Harsco Track Technologies

SERVICE BULLETIN MAINTENANCE OF WAY EQUIPMENT

DATE: 9-8-2004 **BULLETIN NO:** 04-008

TITLE: REINFORCEMENT GROUP #203160

FIGURE 1

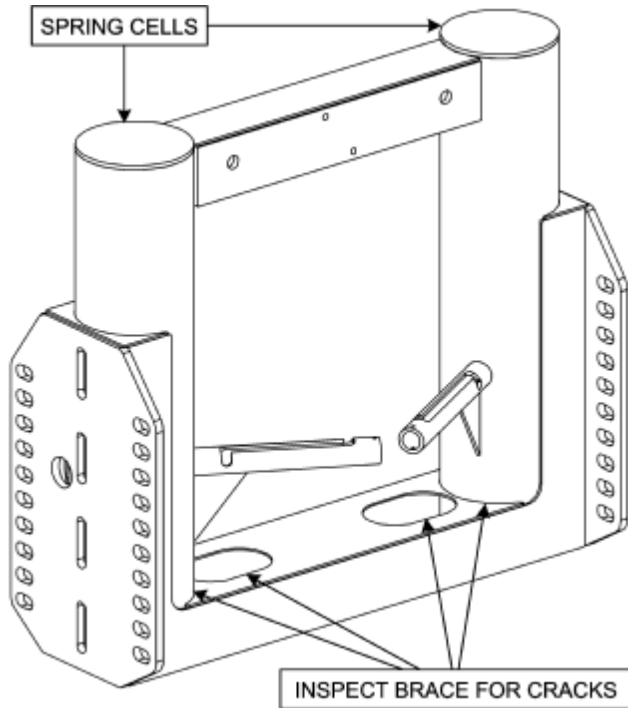
SUPPORT BRACE INSPECTION - See Figure 1

1. Inspect the lower support brace located in-between the spring cells of front rail pilot unit frame for cracks as shown in Figure 1.
2. If any cracks are found and it is desired to reinforce the support brace, order one Reinforcement Group #203160 per vehicle and install per the Instructions in this Service Bulletin.

FIGURE 2

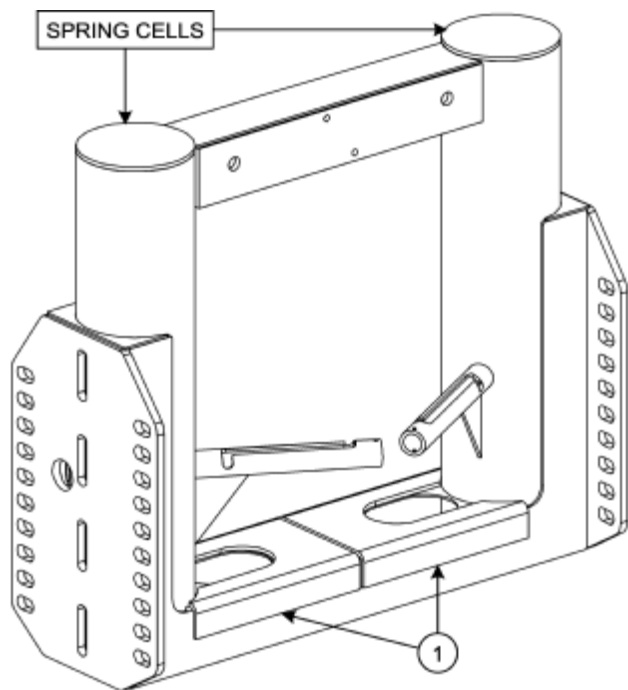
REINFORCEMENT GROUP INSTALLATION - See Figure 2 and Figure 3

3. **Important:** Before welding on the vehicle, disconnect all electrical cables from the battery and from the alternator. Also refer to the vehicle Operator's Manual for any additional precautions that must be taken before welding on the vehicle.
4. Thoroughly clean the existing support brace and spring cells of the front rail pilot unit frame of all dirt, grease, rust, etc. where the two support plates (1) will be welded to.
5. Lay the two support plates (1) on top of the lower support brace in-between the spring cells as shown in Figure 2 and weld in place per the weld symbols shown in Figure 3.

LAY SUPPORT PLATES (1) ON TOP OF LOWER SUPPORT BRACE IN-BETWEEN SPRING CELLS AND WELD IN PLACE.
NOTE: SOME APPLICATIONS MAY REQUIRE GRINDING OF THE SUPPORT PLATES (1) FOR PROPER FIT.

FIGURE 3

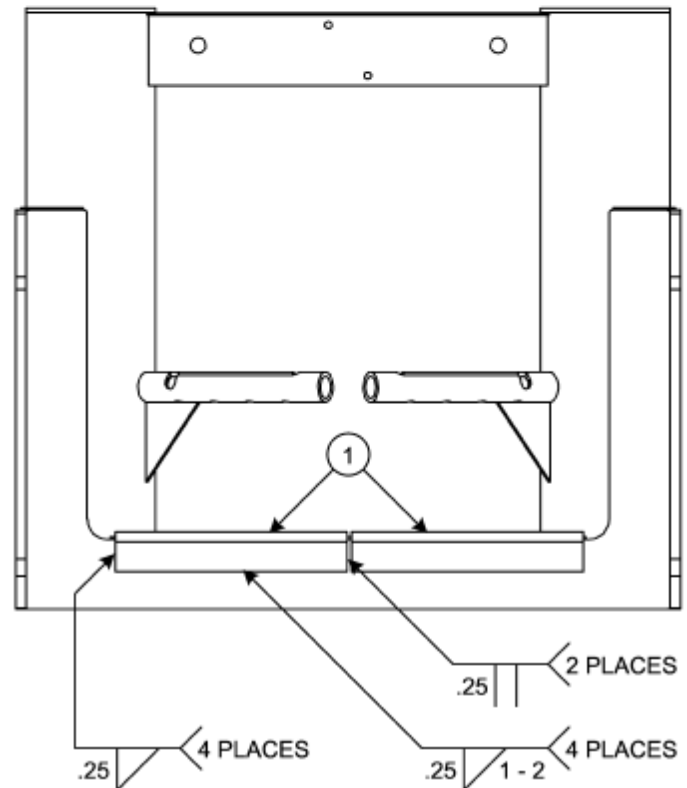
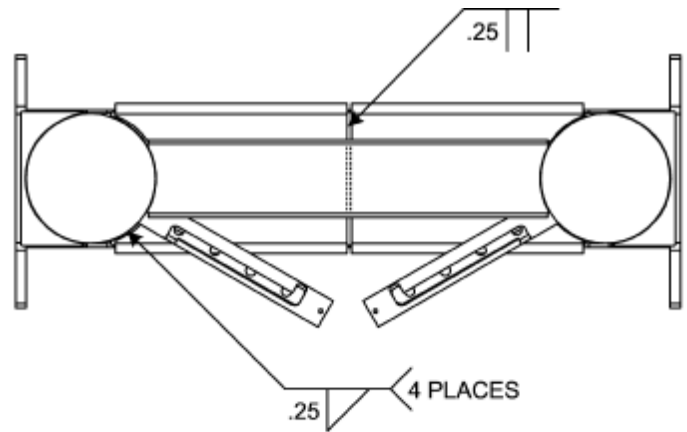
Note: Some applications may require grinding of the support plates (1) for a proper fit.
